Response to NRC Review Comments
Transmitted by Letter Dated June 22, 2001,
to the Nuclear Energy Institute Relating to

PWR Materials Reliability Program
Interim Alloy 600 Safety Assessment for US PWR Plants (MRP-44)
Part 2: Reactor Vessel Top Head Penetrations
EPRI TP-1001491, Part 2, May 2001

MRP 2001-050NP

Response to NRC Review Comments Relating to

Figure 1
Locations of Leaking CRDM Nozzles at Oconee and ANO-1

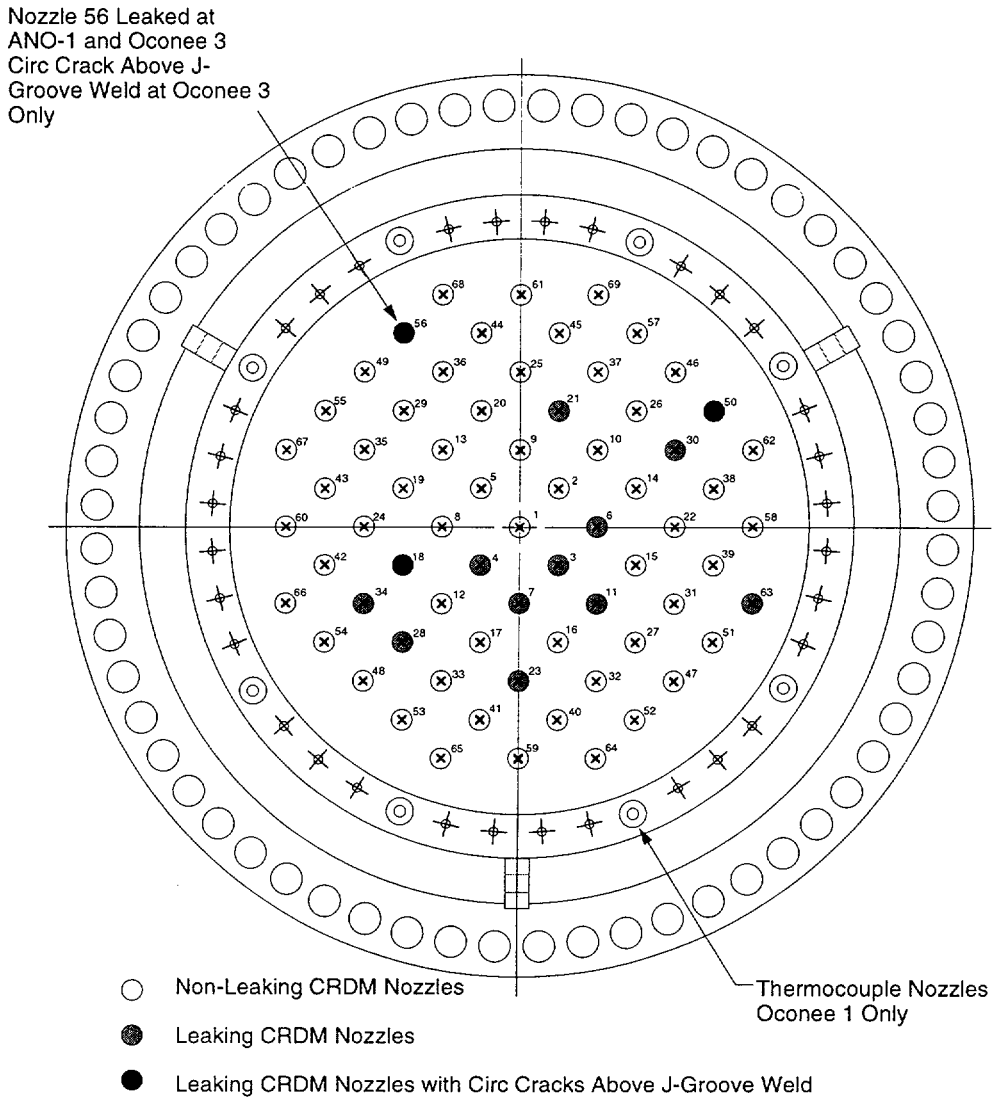
"Appropriate consideration of the interference fit incorporated into the initial fabrication of the vessel head penetrations (VHPs) is important in evaluating the ability of visual leakage detection methods (e.g., boric acid walkdowns) to accurately identify through-wall degradation at the subject locations. While the recent instances of cracking in several VHPs at ANO-1 and Oconee Units 2 and 3 indicate that it is possible to detect through-wall flaws caused by primary water stress corrosion (PWSCC) based on boric acid walkdowns that can look under the insulation, the information provided in Section 3 of the MRP-44, Part 2 report does not support the conclusion that these events were "bounding" (i.e., that, for a similar size through-wall flaw at some other facility, an equivalent or greater amount of leakage would be expected)."

- As shown in Figure 1, Oconee and ANO-1 experience demonstrates that leakage can be detected from nozzles adjacent to the central nozzle and in peripheral locations. This provides confidence that leakage can be detected regardless of location on the head.

Figure 3
Actual Interference Fits of Leaking CRDM Nozzles at Oconee 1, 2 and 3 and ANO-1

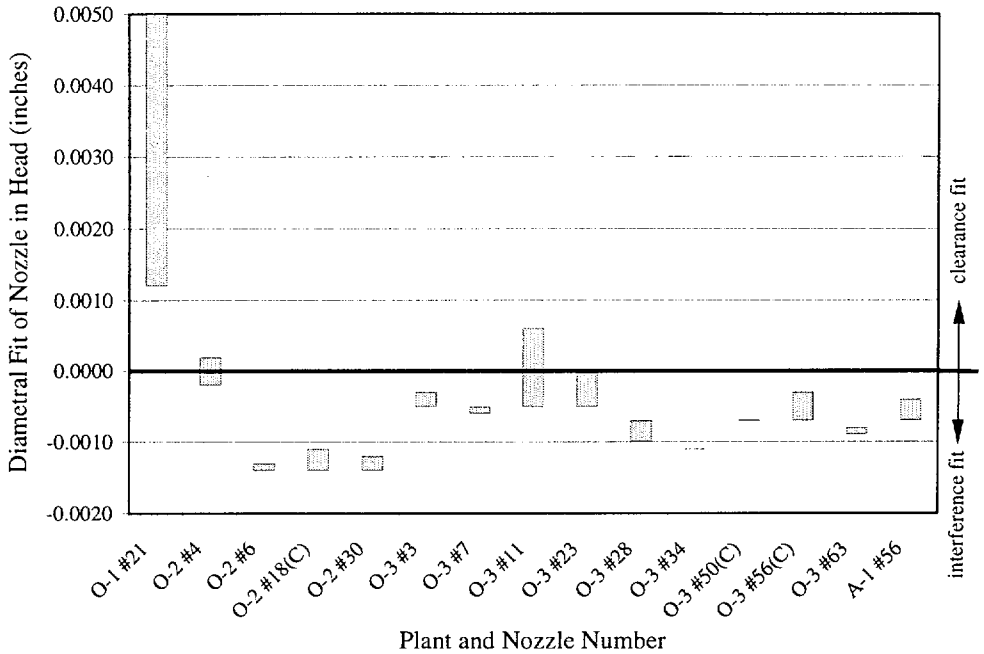
"In order to better understand the leakage potential of PWSCC at VHP locations, and to assist in understanding how comparisons can be made to the leakage potential for VHPs at other facilities, the staff request additional information detailing the precise interference fits (as opposed to a range of values) for the VHPs which leaked at ANO-1 and Oconee."

Figure 3 shows the range of fits for the leaking CRDM nozzles at Oconee and ANO-1. The information provided during the June 7 meeting for Oconee 1, Oconee 3 and ANO-1 has been supplemented with data for the four leaking nozzles at Oconee 2. The three nozzles found to have circumferential cracks above the J-groove weld are appended with "(C)" in the figure.

The data in Figure 3 show that one nozzle had a clearance fit rather than the specified small interference fit. The remaining nozzles had at least one end of the interference fit region within the specified tolerance. It should be noted that three of the four leaking nozzles at Oconee 2 had interference fits of 0.0014 inches at one end and at least 0.0011 inches at the other end. In summary, leaks have been confirmed from fourteen nozzles with confirmed initial interference fits, including three nozzles with at least 0.0014 inches of assembly interference.

Figure 4
Typical FEA Model of Central CRDM Nozzle

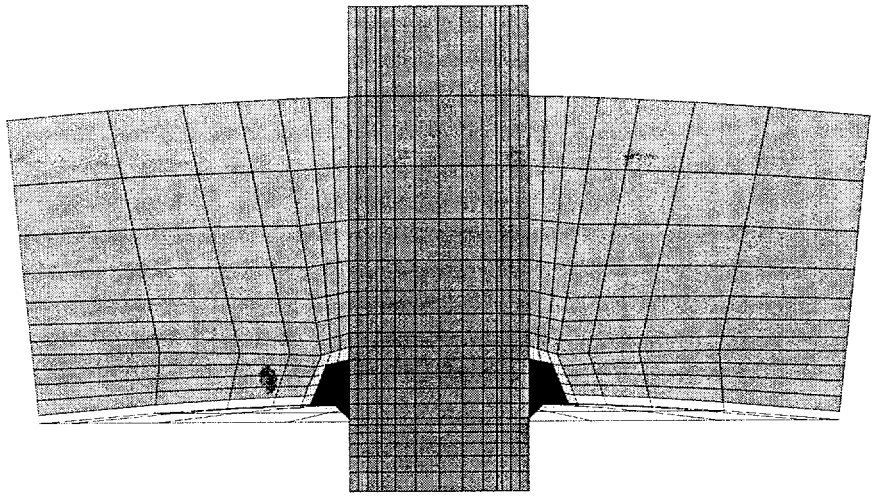
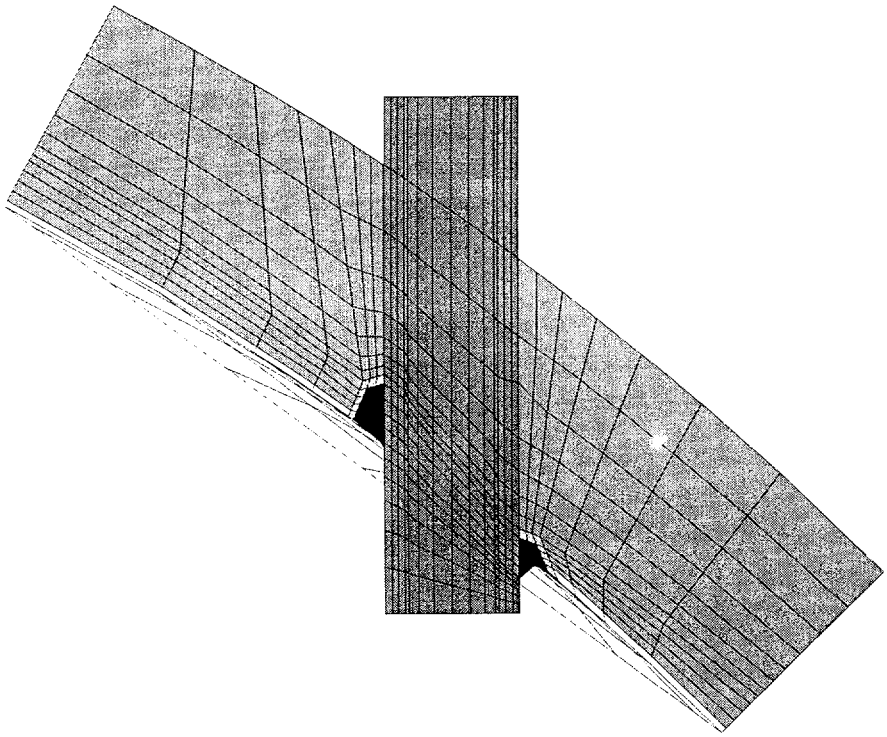
"The staff notes that, based on information in ASME Code Section II, Part D, the coefficient of thermal expansion for Alloy 600 is slightly greater than that for low alloy vessel steels throughout the temperature range of interest (70 °F to 600 °F). This would lead to the conclusion that the magnitude of the interference fit would grow as the vessel was heated up from room temperature to operating temperature. Further, internal pressurization of the VHP nozzle may be expected to further expand the nozzle into the vessel head penetration. Other potential effects related to RPV head distortion at pressure, flange rotation, and/or vessel head penetration ovalization are not discussed in Section 3.0. Address how these factors may affect central and peripheral VHPs differently. Provide additional information to support your statement that "...analyses show that the initial fit tends to open up at operating temperature and pressure." Provide details on the finite element analysis (FEA) of the RPV head used to support this statement, including modeling assumptions, boundary conditions and results."

Second order effects such as deflection and ovalization of oblique nozzles under pressure loading are assessed by finite element modeling of the nozzle and vessel head. Each of the NSSS vendors and EPRI has models of reactor vessel top head nozzles. Figures 4 and 5 show typical models of central and peripheral row CRDM nozzles and the associated J-groove welds. The models shown include the nozzle, a sector of the vessel shell, J-groove weld, J-groove weld buttering, and vessel cladding. Boundary conditions are imposed on the sector of the vessel shell to simulate the nozzle being installed in a complete spherical shell, and to model the initial

Finite element analyses show that oblique CRDM nozzles displace laterally if a clearance opens up between the nozzle and bore under operating conditions. The resultant displacement reduces the leak path at some locations and increases the leak path at other locations. Typical analysis results for a peripheral CRDM nozzle are shown in Figure 6. The net effect shown in this figure is to open up a spiral leak path which has less flow resistance than a uniform annular gap.

Finite element analyses of a model including the nozzle, vessel shell, and flange show that flange tensioning and resultant rotation increase the ovality of peripheral row CRDM nozzles by approximately 20%. This effect is small and, as noted in the previous paragraph, should decrease the flow resistance.

Figure 7
Visual Inspection of Oconee 3 Reactor Vessel Head (Leaking Nozzle 56)

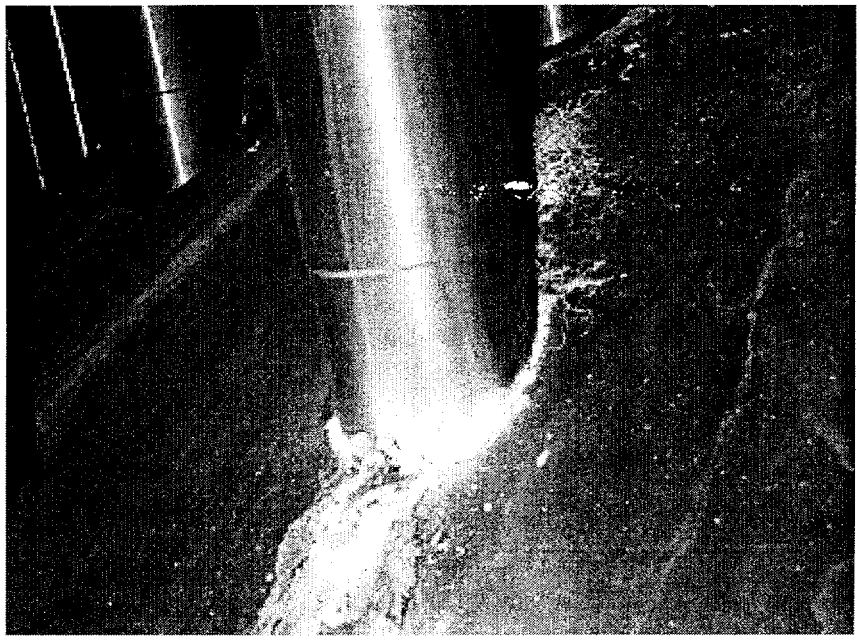
"At a public meeting on June 7, 2001, at NRC headquarters, the industry representatives described visual examinations conducted under the insulation at several PWRs. Provide any photographic documentation that can serve to demonstrate the expected conditions, accessibility and inspectability of the RPV head for such arrangements."

- Figure 7 is Oconee 3, where visual inspection was performed through access ports that had previously been cut in the shroud. Leakage is clearly visible in the photograph.

Figure 15
Stress Analyses of Peripheral CRDM nozzle in Intact (a) and Cracked (b) Configurations

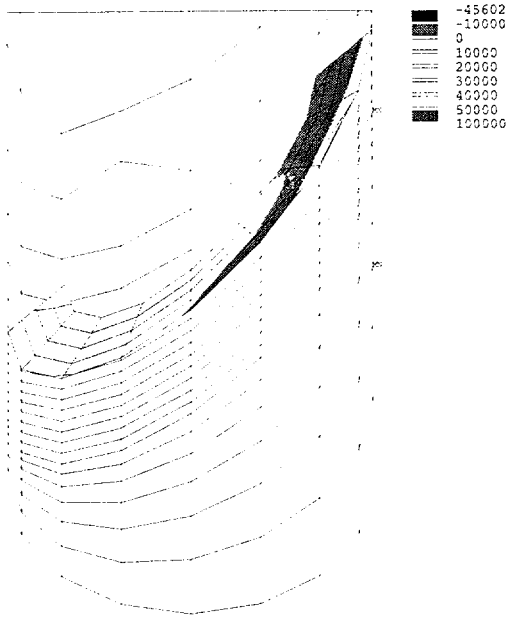
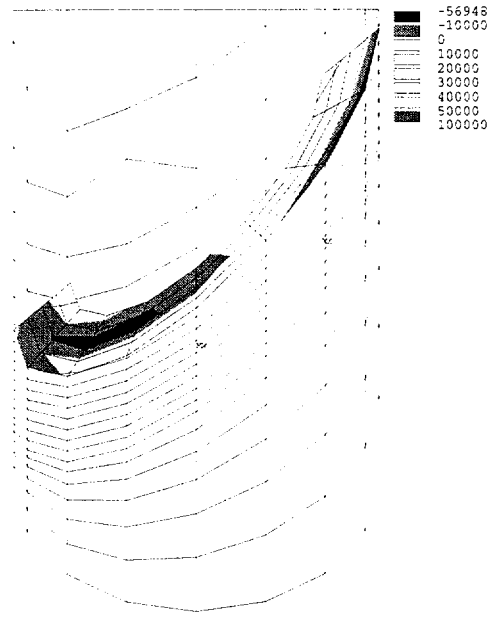
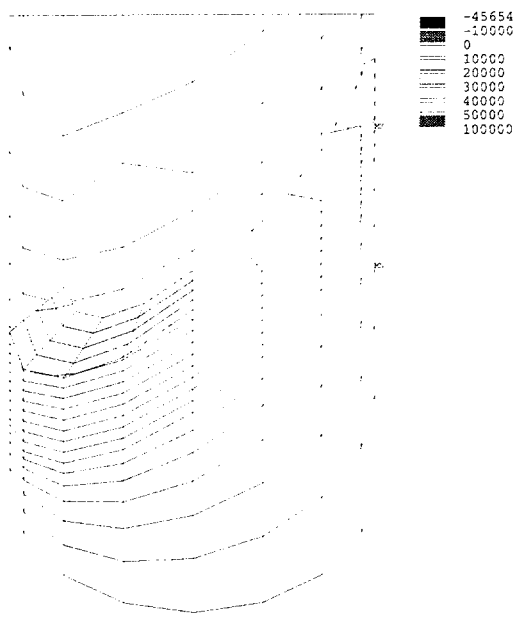
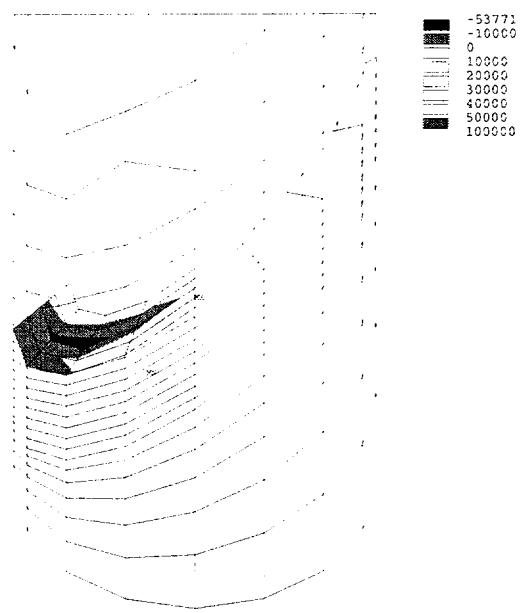
"At a public meeting on June 7, 2001, at NRC headquarters, the industry representatives described finite element analyses (FEA) for circumferential cracks in peripheral CRDM nozzles. Provide details of the FEA modeling assumptions (such as symmetry, boundary conditions and residual stresses), the resultant stresses, and the applied stress intensity factors. How do these parameters change (e.g., stress redistribution) with crack growth in the nozzles?"

Analysis results were presented at the June 7 meeting showing stresses parallel to and perpendicular to the J-groove weld for a peripheral nozzle in the intact operating condition, including the effects of welding residual stresses and hydrostatic testing prior to operation, and with the weld cracked 180° around on the uphill side of the nozzle at the elevation of the weld root. These results are repeated in Figure 15, which also shows the values for the stress contours. These data show that stresses are significantly reduced after cracking has removed some of the constraint that caused high welding residual stresses.

The model shown in Figures 4, 5 and 15 was not used to calculate crack tip stress intensity factors directly. Stress intensity factor calculations are currently being sponsored by the MRP using the finite element analysis results as inputs. Until such time as the finite element based stress intensity calculations are completed, calculations of crack growth have been performed using more traditional models such as described under Section 5.0 Comment 1.
